INITIAL FIRE SAFETY INSPECTION REPORT

PNG (BD) Ltd. (NEW SHED)

RSC ID: 24471

Date: 17-August-2022

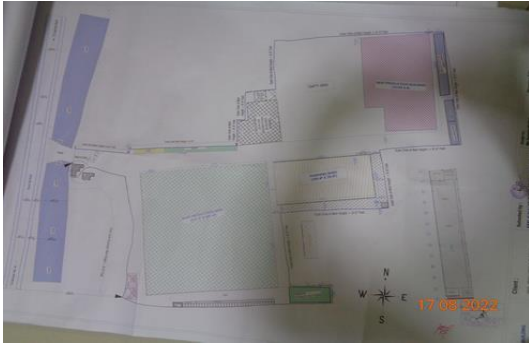
F-2	Egress	Handrails are not provided in the both side of the exit ramp.	Ramps shall be provided with handrails on both sides of the ramp. Handrails shall have a minimum height of 865 mm (34 in.) and a maximum height of 965 mm (38 in.) as measured from the leading edge of the tread.	Within 2 months
